Service Bulletin 1012: DRO Wiring Retrofit

Issued January 27, 2017

4190 HiTorque Mini Mill with serial numbers in the range 60700-60850. (You can find the serial number on the base by turning the Y-axis to move the table back and then looking under the bellows chip guard, as shown at the right.)

Retrofit Kit

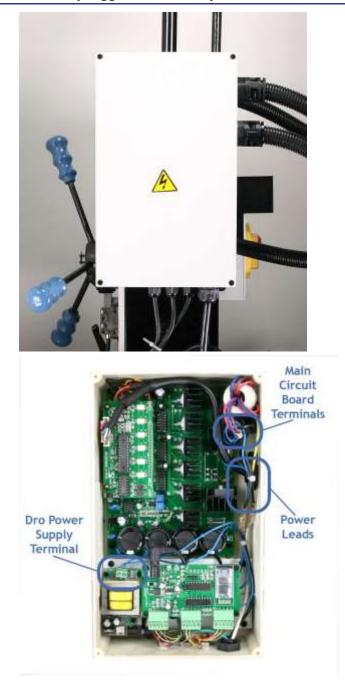
The retrofit kit consists of two wires with terminals on one end, and two clamp-on terminals as shown at the right.

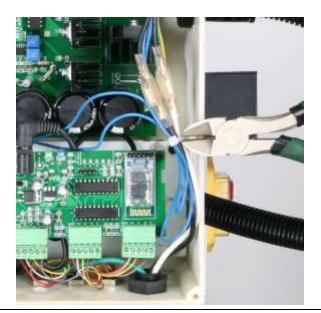
1. Remove the cover from the control box on the back of the column.

How to install Quick Splice Connectors

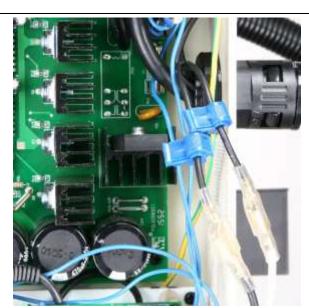
- a) Place the wire across the side of the quick splice connector without the conductor.
- b) Fold the quick splice connector over the wire.

c) Clamp the quick splice connector with pliers until it latches. 3. Clamp a quick splice connector on each of the two black power leads above where they connect to the power cord.
